# Meath County Council Dunshaughlin Public Realm Scheme

DMURS Quality Report

### STAGE 1 ROAD SAFETY AUDIT

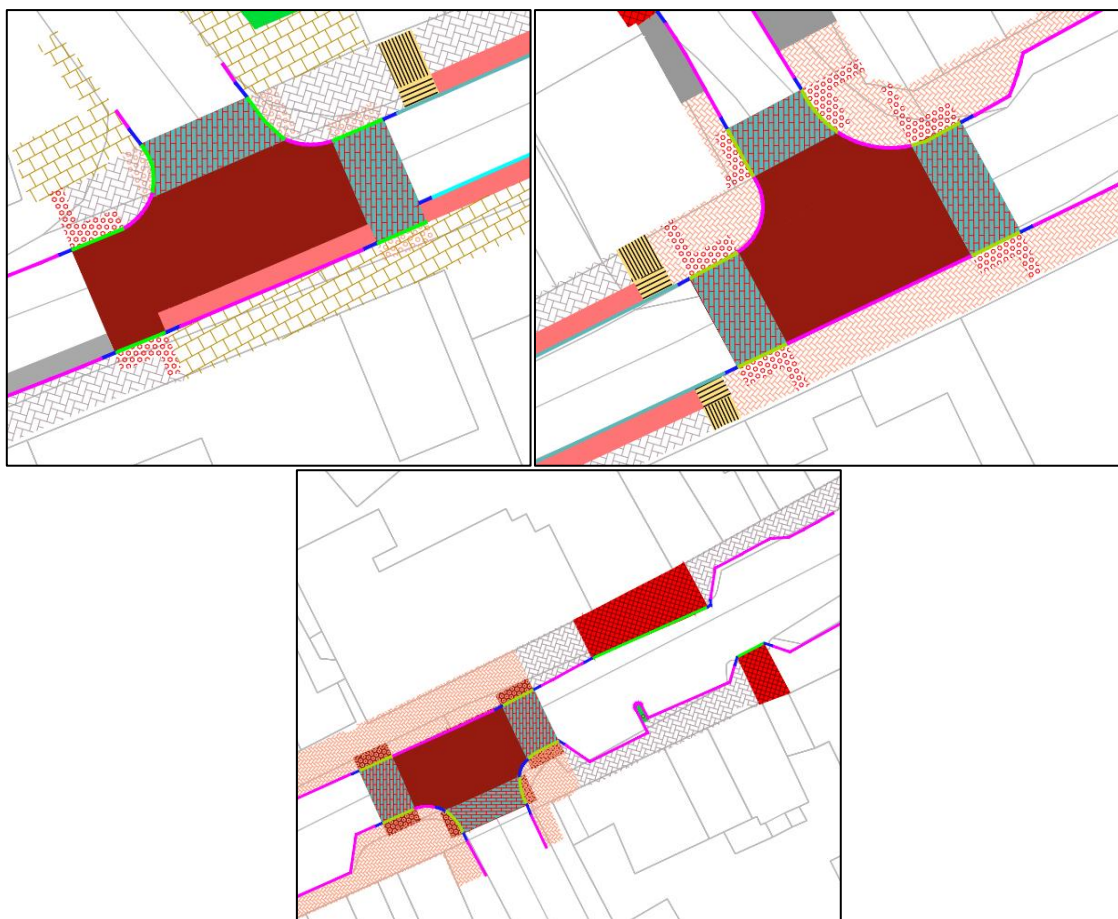
Within the existing extents of the scheme, there is a lack of drop kerbs facilitating pedestrian desire lines and no evidence of tactile paving at key junction crossings as well as incorrect tactile provision and desire lines. This was noted at the Supervalu / The Dales Junction and key points along the R147. It has been noted that point hazards provide obstructions along the footways and where vehicle access points are present across existing footways, vehicular priority is provided instead of continuity of pedestrian infrastructure.

Ensure Tactile paving and drop kerbs of appropriate size and orientation along pedestrian desire lines at road crossings, improve pedestrian desire lines around junctions and re-prioritise individual vehicular access points for pedestrian priority where they cross the footway.

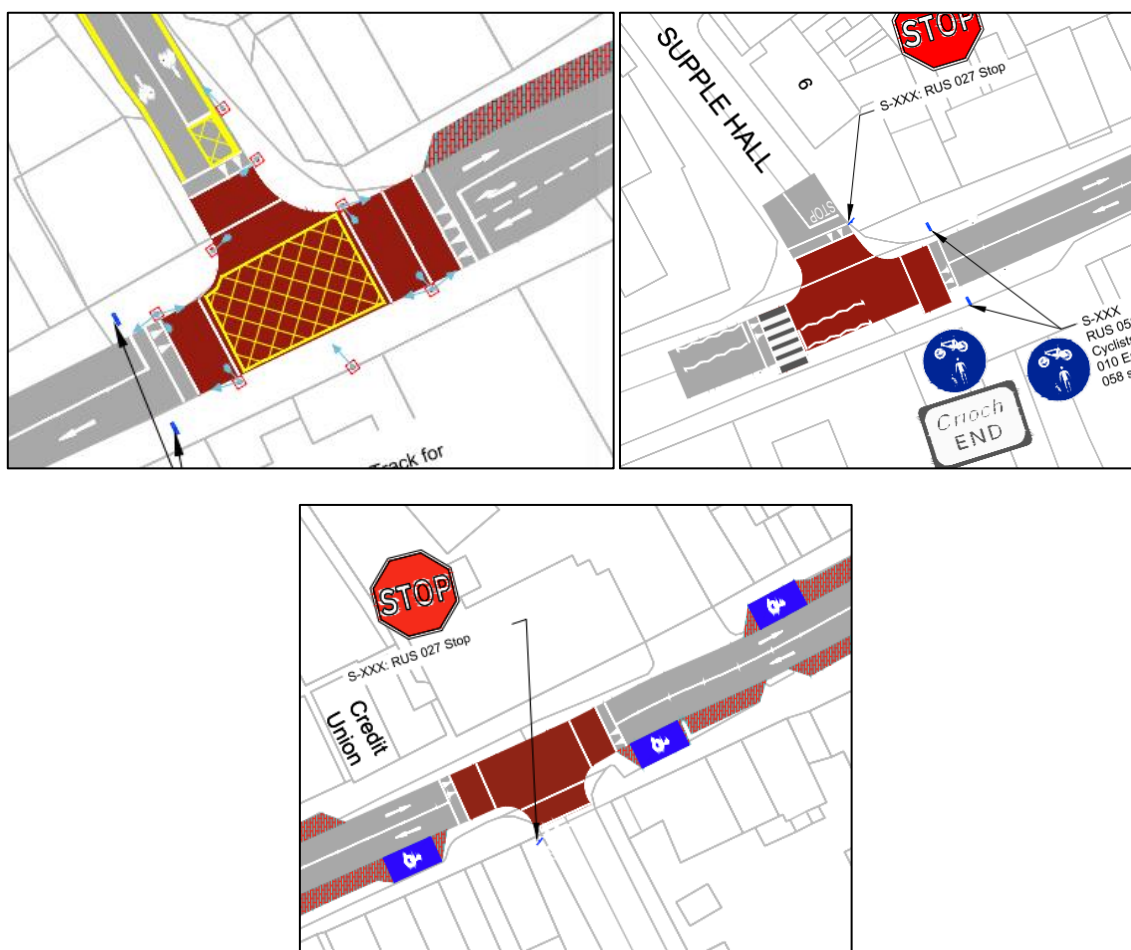
Currently in Dunshaughlin there is a significant issue regarding accessibility and crossing of the R147 to facilitate pedestrian desire lines. Within the study area which encompasses 3 No. Junctions with the R147 1) Supple Park, 2) The Dales and 3) The Bungalows, only 2 pedestrian crossings (controlled or uncontrolled) are present. This also presents an accessibility issue for mobility impaired users and those using the accessible parking currently situated within the courthouse environs.

Improve desire lines and incorporate pedestrian crossing infrastructure (controlled and uncontrolled) along the R147 at junction locations. Provide accessible parking along both sides of the R147 Main Street

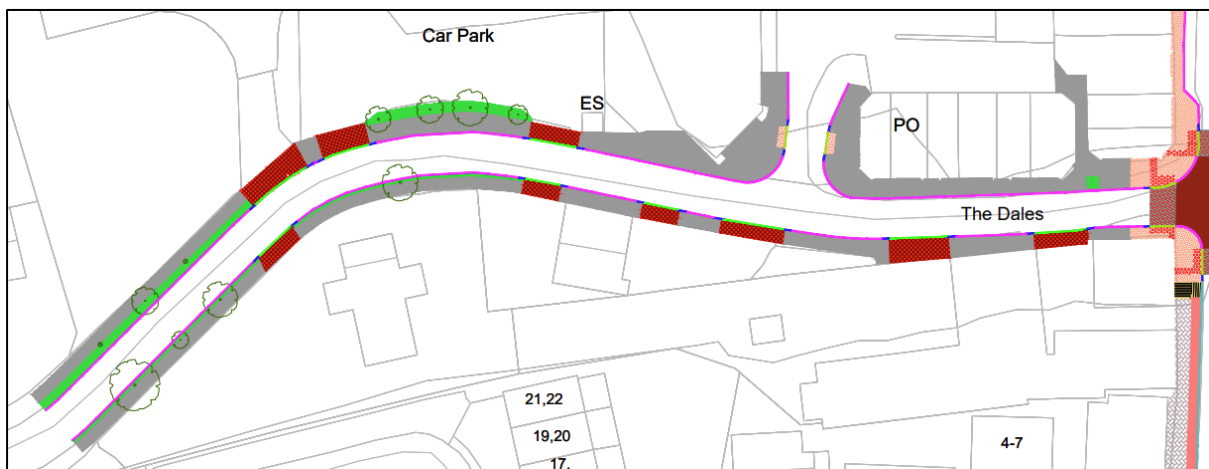
Existing Footpath widths are constrained at key locations preventing pedestrians from using the infrastructure comfortably with street furniture in the way e.g. Lighting Columns, bollards. There is also a noted lack of segregated infrastructure along the westbound side of the Dales road which has lengths of uncontrolled vehicular access raising significant safety concerns.

Provide continuous widened infrastructure along the Dales Road, removing point constraints and re-prioritising the area to provide segregated pedestrian infrastructure with controlled vehicular access points

*Figure 2-1: Example of proposed tramline and ladder*

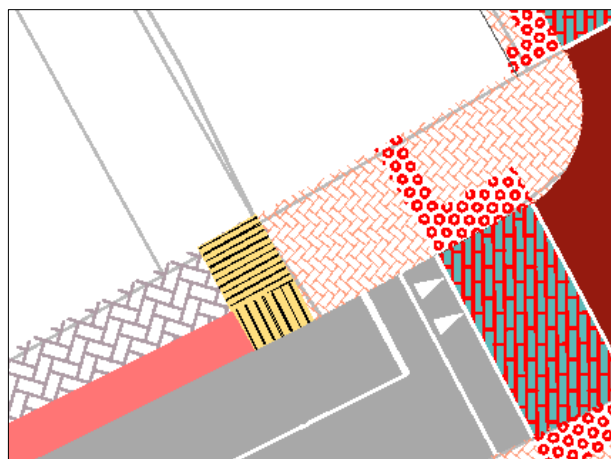
The Audit Team noted the proposed buff tramline and ladder paving is oriented in the incorrect direction. The Audit Team are concerned this may result in a visually impaired person entering into the cycleway in conflict with a cyclist resulting in a collision.

The design team should provide tramline and ladder paving in the correct orientation.

Figure 2-3: Proposed Parking (11514 -1008-04)

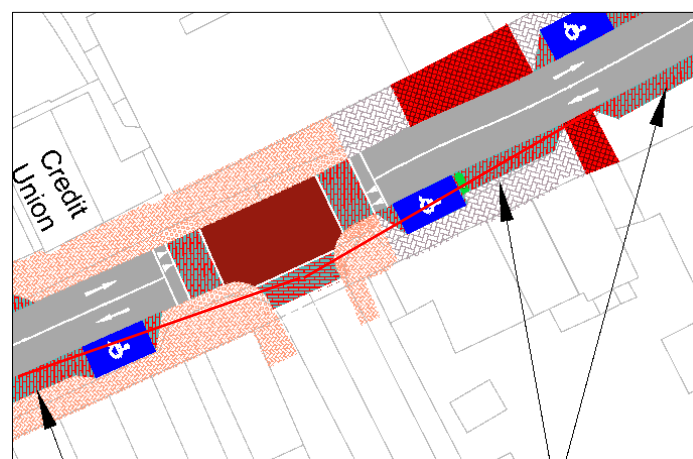
The Audit Team noted parking is not restricted within the visibility splays at the R417/Bungalow junction. The Audit Team are concerned parking may occur within the visibility envelopes obstructing the visibility to / from vehicles. Vehicles edging into the carriageway may result in side-swipe collisions with passing vehicles on the mainline.

The design team should provide clear unobstructed visibility splays.

Figure 2-4: Proposed Parking (11514-1008-04)

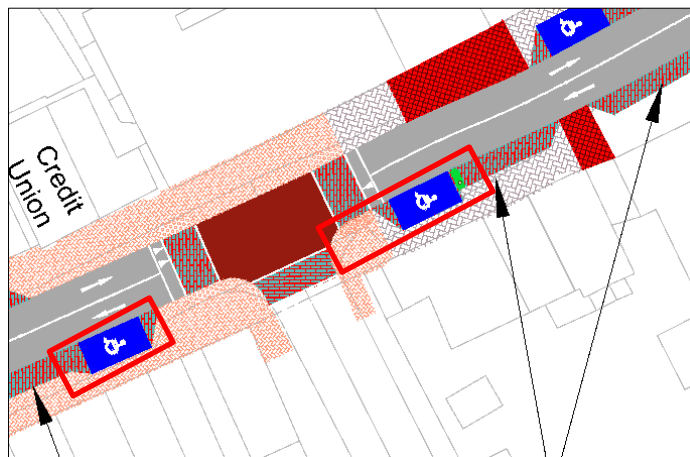
The Audit Team noted the proposed parking is within the within visibility of the R147/Bungalows junction. The Audit team are concerned if vehicles are parked in the disabled bays (i.e. high sided vehicles) it may obstruct visibility to/from pedestrians. This may result in a collision between a vehicle and a VRU.

The design team should remove all obstructions from the visibility envelopes.

Figure 2-5: R147/Supple Park Junction (Drawing 11514-1008-04)

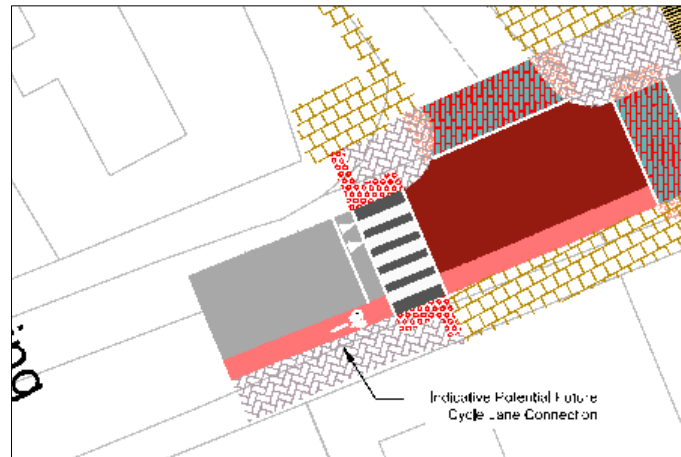
The Audit Team observed the tie-in details for the cycle lane terminates suddenly in the carriageway. The Audit Team are concerned the sudden termination of the cycleway may result in cyclists entering into the carriageway in conflict with vehicles. This may result in a rear-end / side-swipe collision between cyclists and vehicles.

The design team to provide warning of the merging of cyclists with vehicles on the mainline.

Figure 2-7: R147/Supple Park Junction (Drawing (11514 -1008-04)

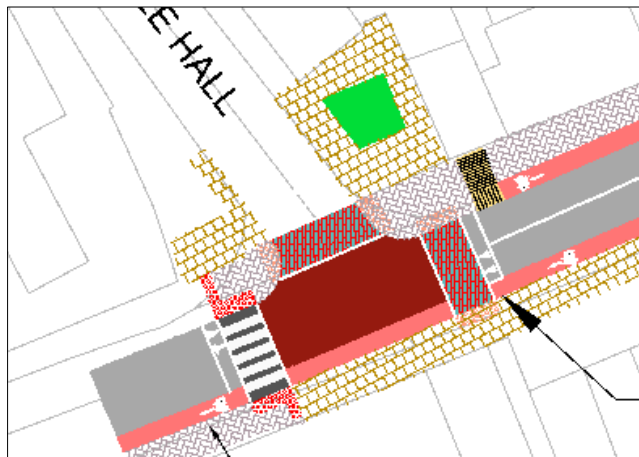
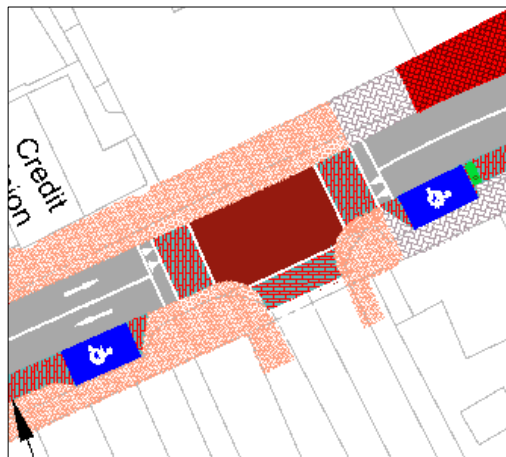
The Audit Team noted the priority T- Junctions have no STOP road markings and no signage. The Audit Team are concerned the lack of priority will result in driver confusion. This may result in a side on collision.

The design team should provide signage and road markings as per the Traffic Signs Manual (TSM).

Figure 2-9: R147/Supple Park Junction (Drawing 11514-2030)

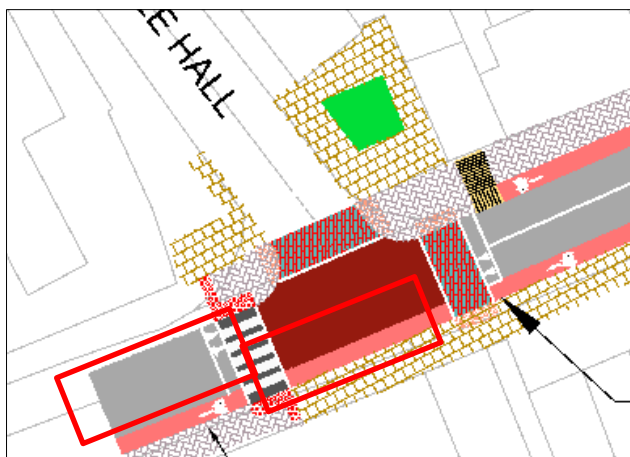
The Audit Team noted the proposed zebra crossing does not having appropriate road markings on approach to the crossing. The Audit Team are concerned in the absence of the road markings it may result in drivers not reducing speed on approach to pedestrian crossing / giving priority to the pedestrian. This may result in a collision between a VRU and a vehicle.

The design team should propose road markings in accordance with the TSM.

Figure 2-10: R147/Supple Park Junction (Drawing 11514-2030)

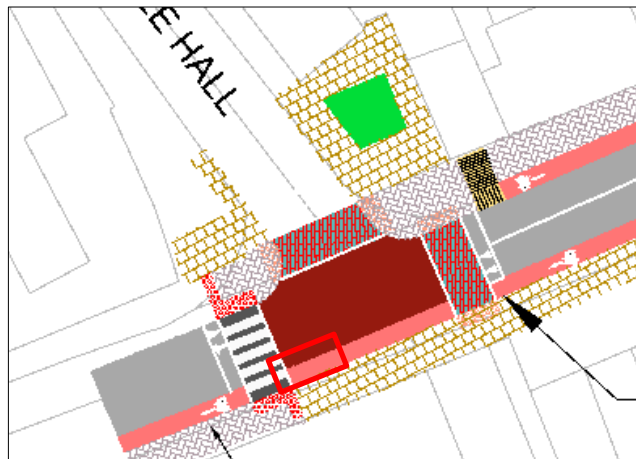
The Audit Team noted the cycle lane has no yield markings on approach to the zebra crossings. The Audit Team are concerned the absence of the road markings may result in confusion on priority. This may result in a collision between a cyclist and a pedestrian.

The design team should provide road markings in accordance with the TSM.

Figure 2-11: R147/Supple Park Junction (Drawing 11514-2030)

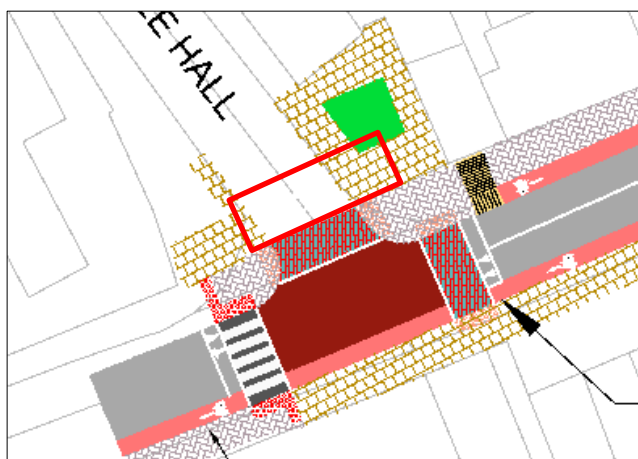
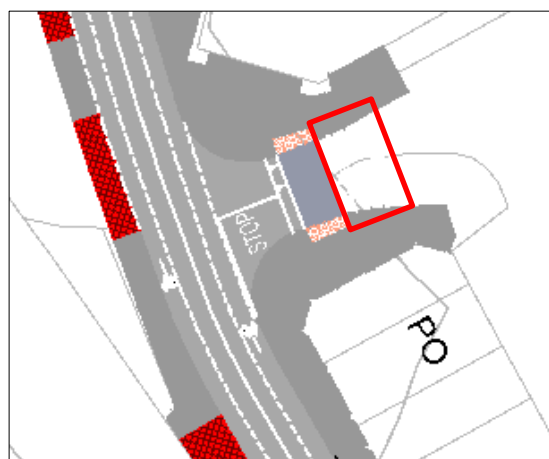
The Audit Team note the Traffic Calming Triangles are not proposed on all approaches to the raised tables. The Audit Team are concerned drivers may hit the raised table at speed resulting in a loss of control of the vehicle which may result in a collision.

The design team should provide road markings in accordance with the TSM.

Figure 2-13: Share Surface Gradient

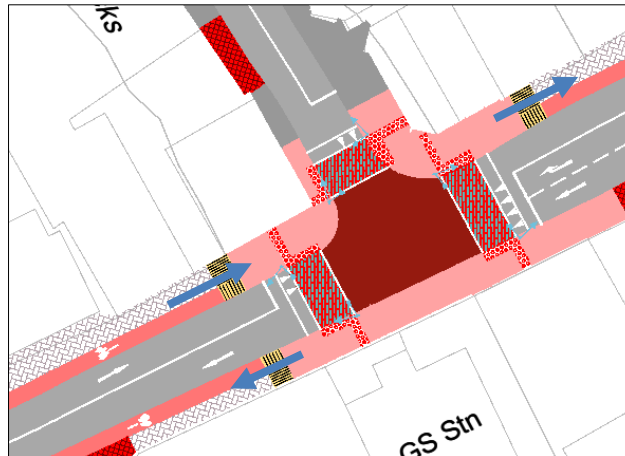
The Audit Team note the proposed footway is elevated above the cycleway. The level difference at the shared space may result in a trip hazard.

The design team should provide an appropriate gradient on approach to the shared surface.

Figure 2-14: Proposed Works (Drawing 11514-1008-04)

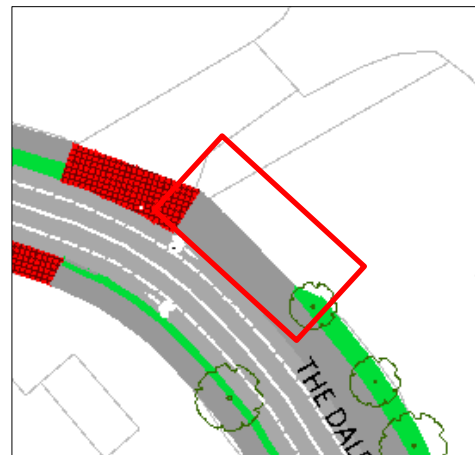
The Audit Team noted the existing carpark entrance has not been incorporated into the design. The Audit team are concerned vehicles may try entering the car park against the one-way exiting traffic system. This may result in a head-on collision.

The design team should include the entrance for the car park into the design.

Figure 2-15: Proposed Advisory Cycle Lane (Drawing 11514-1008-04)

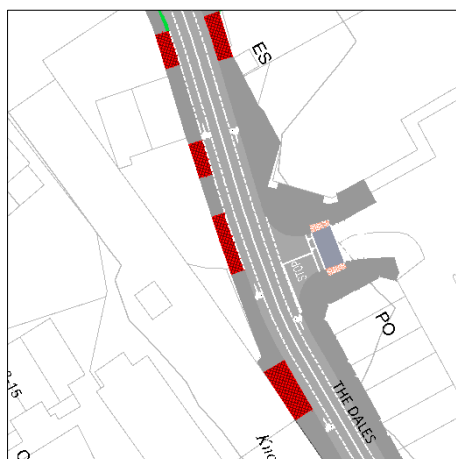
The Audit Team noted advisory cycle lanes are proposed along the Dales. The Audit team are concerned the advisory lanes give the impression of sufficient width for a two-way vehicle to overtake a cyclist. This may result in vehicles driving in close proximity to the cyclist in the same direction of travel, resulting in a collision.

The design team should remove the advisory cycle lane.

Figure 2-16: Carpark Access (Drawing 11514-1008-04)

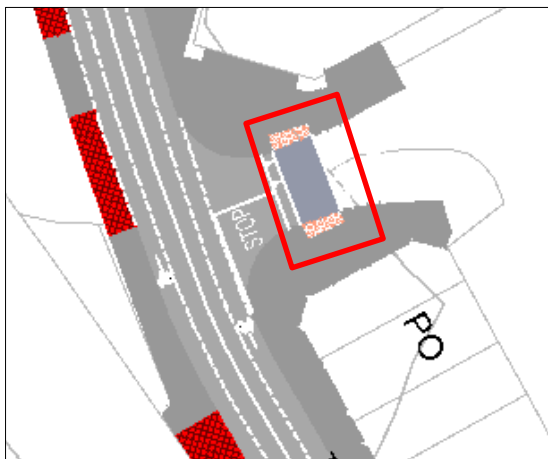
The Audit Team noted the proposed tactile paving is not orientated perpendicular to the carriageway or squared off. The Audit Team are concerned a visually impaired pedestrians may enter the carriageway and cannot exit the carriageway becoming stranded. This may result in a collision between a vehicle and a VRU.

The design team should provide tactile paving perpendicular to the carriageway in accordance with the design standards.

*Plate 3-3: Existing Gully*

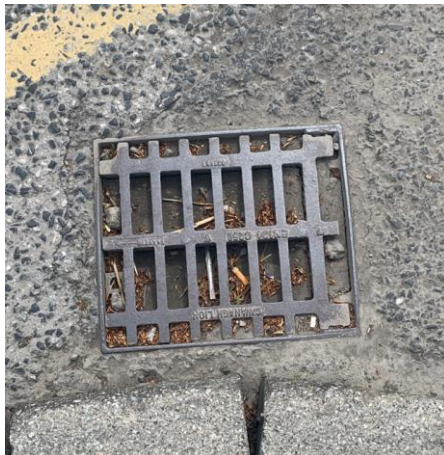
The audit team noted existing gullies on site are blocked with debris.
